dsPIC30F Family Reference Manual Errata Sheet

The dsPIC30F Family Reference Manual (DS70046B) correctly describes the function of the dsPIC30F devices, except for the anomalies described below.

Errata Summary

Figure 5-2: NVM Addressing with TBLPAG and NVM Address Registers

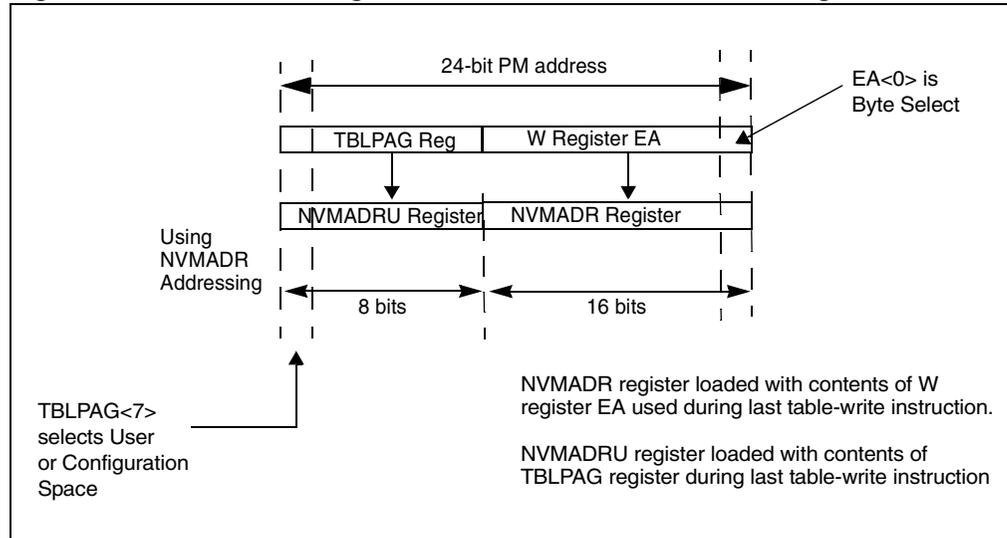
10. Page 5-6, Section 5.3.2 NVMADR Register

On page 5-6, Section 5.3.2 NVMADR Register should be replaced with the following:

5.3.2 NVM Address Registers

There are two NVM Address Registers - NVMADRU and NVMADR. These two registers when concatenated form the 24-bit effective address (EA) of the selected row or word for programming operations. The NVMADRU register is used to hold the upper 8 bits of the EA, while the NVMADR register is used to hold the lower 16 bits of the EA.

The register pair, NVMADRU:NVMADR, capture the EA<23:0> of the last table-write instruction that has been executed and select the row of Flash or EEPROM memory to write/erase. Figure 5-2 shows how the program memory EA is formed for programming and erase operations.

Although the NVMADRU and NVMADR registers are automatically loaded by the table-write instructions, the user can also directly modify their contents before the programming operation begins. A write to these registers will be required prior to an erase operation, because no table-write instructions are required for any erase operation.

Figure 17-21: 10-bit A/D Converter Analog Input Model

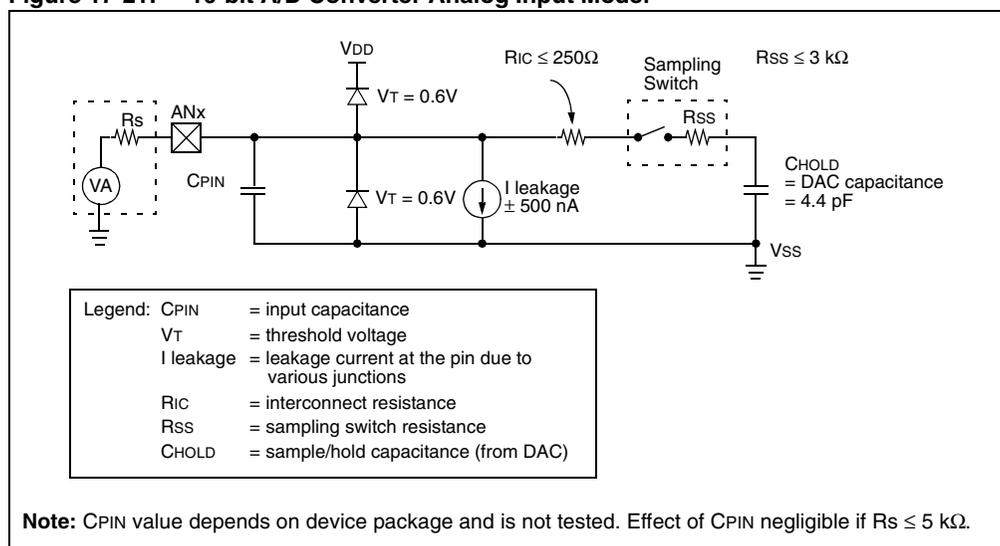
32. Page 17-46, Section 17.16 A/D Sampling Requirements

The entire Section 17.16 should be replaced with the following text and figures:

The analog input model of the 10-bit A/D converter is shown in Figure 17-21. The total sampling time for the A/D is a function of the internal amplifier settling time and the holding capacitor charge time.

For the A/D converter to meet its specified accuracy, the charge holding capacitor (CHOLD) must be allowed to fully charge to the voltage level on the analog input pin. The source impedance (R_s), the interconnect impedance (R_{IC}), and the internal sampling switch (R_{SS}) impedance combine to directly affect the time required to charge the capacitor CHOLD. The combined impedance of the analog sources must therefore be small enough to fully charge the holding capacitor within the chosen sample time. To minimize the effects of pin leakage currents on the accuracy of the A/D converter, the maximum recommended source impedance, R_s , is 5 k Ω . After the analog input channel is selected (changed), this sampling function must be completed prior to starting the conversion. The internal holding capacitor will be in a discharged state prior to each sample operation.

At least 1 TAD time period should be allowed between conversions for the sample time. For more details, see the device electrical specifications.

Figure 18-11: 12-bit A/D Converter Analog Input Model

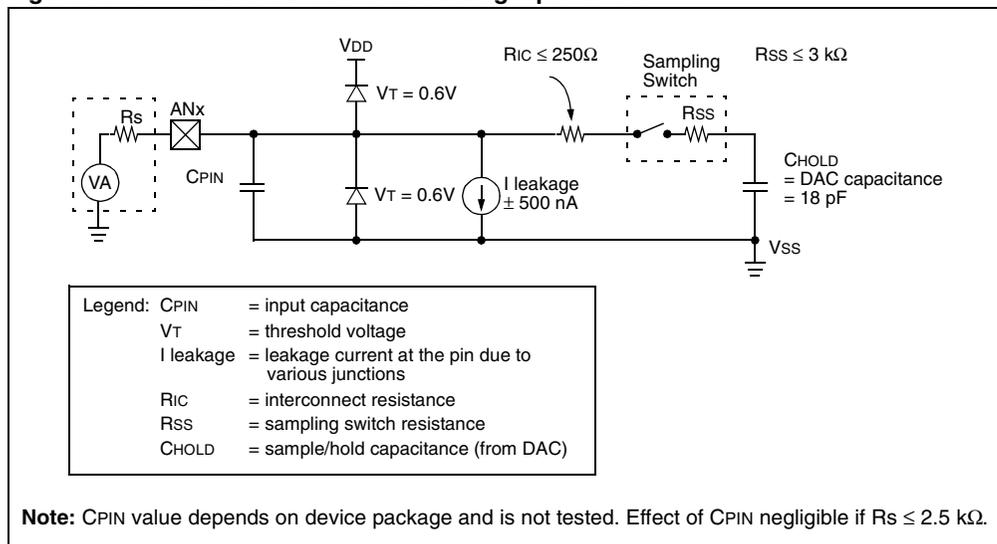
34. Page 18-27, Section 18.15 A/D Sampling Requirements

The entire Section 18.15 should be replaced with the following text and figures:

The analog input model of the 12-bit A/D converter is shown in Figure 18-11. The total sampling time for the A/D is a function of the internal amplifier settling time and the holding capacitor charge time.

For the A/D converter to meet its specified accuracy, the charge holding capacitor (CHOLD) must be allowed to fully charge to the voltage level on the analog input pin. The source impedance (RS), the interconnect impedance (RIC), and the internal sampling switch (RSS) impedance combine to directly affect the time required to charge the capacitor CHOLD. The combined impedance of the analog sources must therefore be small enough to fully charge the holding capacitor within the chosen sample time. To minimize the effects of pin leakage currents on the accuracy of the A/D converter, the maximum recommended source impedance, RS, is 2.5 kΩ. After the analog input channel is selected (changed), this sampling function must be completed prior to starting the conversion. The internal holding capacitor will be in a discharged state prior to each sample operation.

At least 1 TAD time period should be allowed between conversions for the sample time. For more details, see the device electrical specifications.
